Service Kit

753-0723

CODE: RT-135

SUBJ: Rail replacement on a 390 tiller.

Figure 1

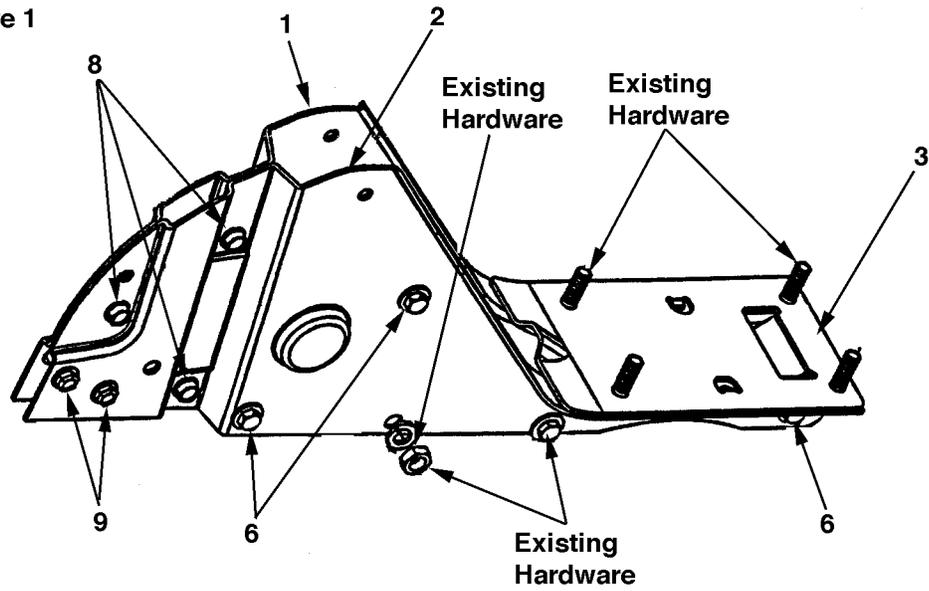
PROBLEM: Left side rails (786-0029) and right side rails (786-0028) will now be replaced with a new left side rail (**786-0139**) and a new right side rail (**786-0138**). When replacing either old rail it will be necessary to replace both sides with new rails provided in kit.

9. Remove the wheel hanger bracket.
10. Remove the rails from the tiller chain case assembly.
11. On the top end of the tiller chain case (686-0009) enlarge the two mounting holes with a 1/2" drill bit. This will allow clearance for the shoulder bolts (**738-0934**).

12. Mount the two new rails (**786-0139**) left and (**786-0138**) right to the chain case using the bolts provided in the service kit and using the existing nuts and washers. See figure 1 for hardware location.

Figure 2

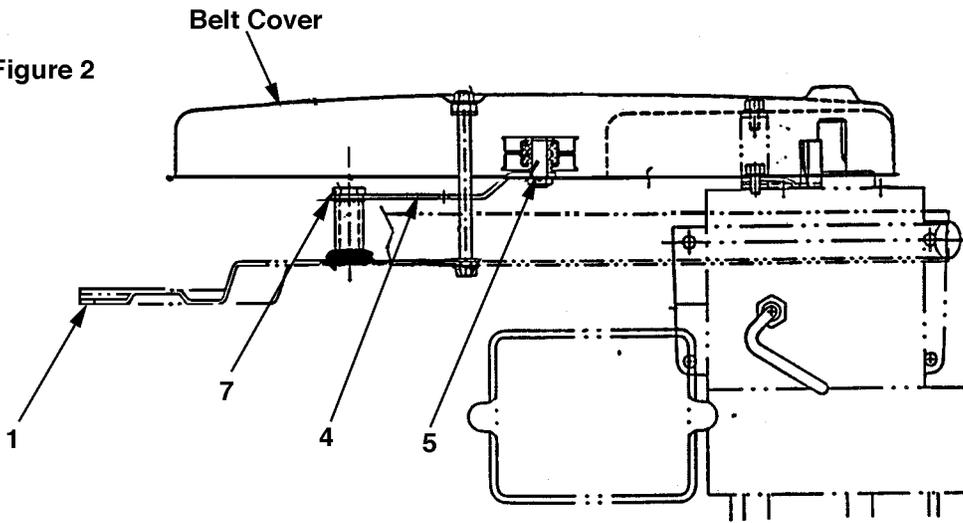
15. Replace tine shield and engine. Bolt engine to the frame using the existing hardware.
16. Replace the old tiller idler bracket with the new idler bracket (**786-0144**). The new idler bracket belt keeper (**786-0149**) should be added to the idler assembly. Mount the idler bracket to the frame half with a should bolt (**738-0930**) provided in the kit.
